Acoustic advice on the modification of the building pressurisation system for Sydney Modern

Sydney Modern is seeking the modification of the building pressurisation system on top of the Gallery 1. This letter provides acoustic advice to support the modification (Mod 6) of the design change.

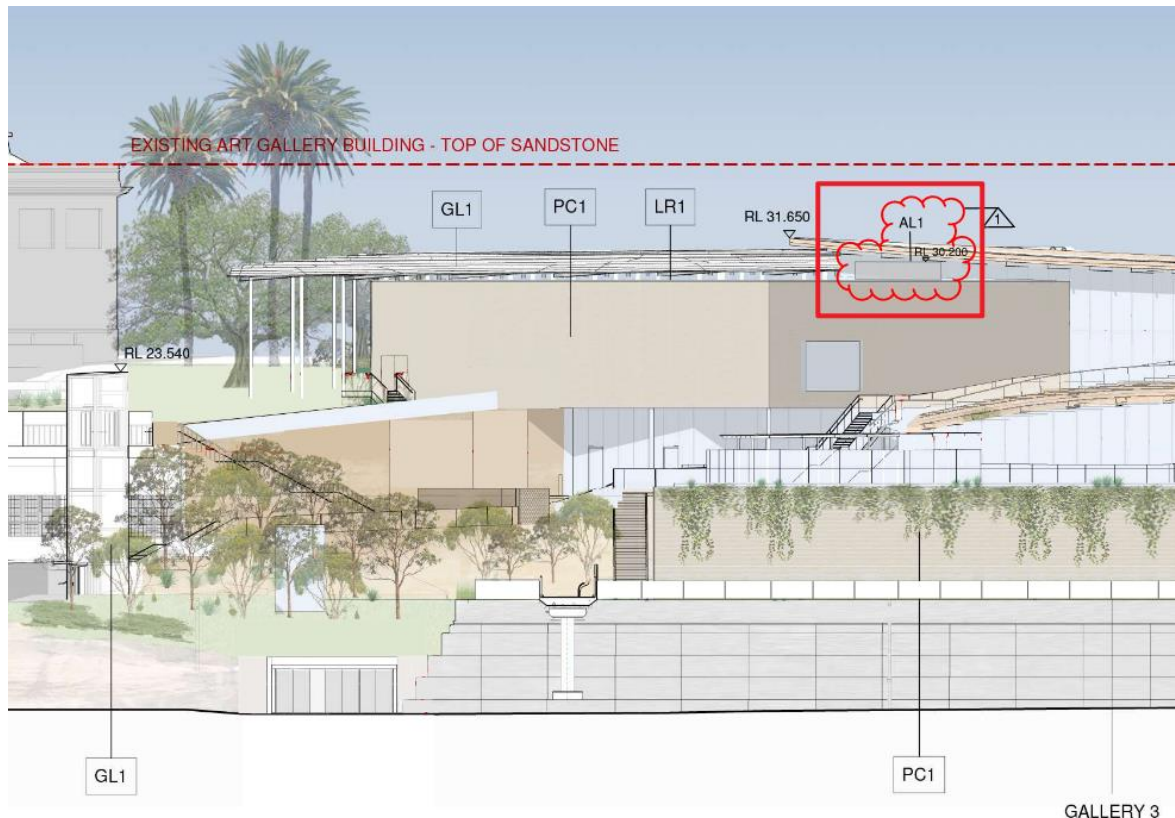
The proposed modification of building pressurisation system includes two building pressurisation fans being added to the roof of the Gallery 1, as clouded in the figure below. The detailed architectural changes are provided in Drawing No. DA_3001 Rev N.

An acoustic assessment for noise emission from these fans has been carried out. The following acoustic treatments have been proposed and included in the design modification to mitigate the noise emission:

- Ductwork to be lined with minimum 100mm internal lining to attenuate the in-duct noise
- Acoustic lagging to the building pressurisation fans to reduce the casing radiated noise
- A solid acoustic screen (1000mm-1050mm high) around the area of building pressurisation fans

Based on the acoustic predictions with proposed acoustic mitigation measures, compliance to the noise limits is achieved to the nearest noise sensitive receivers including onsite occupiable areas.
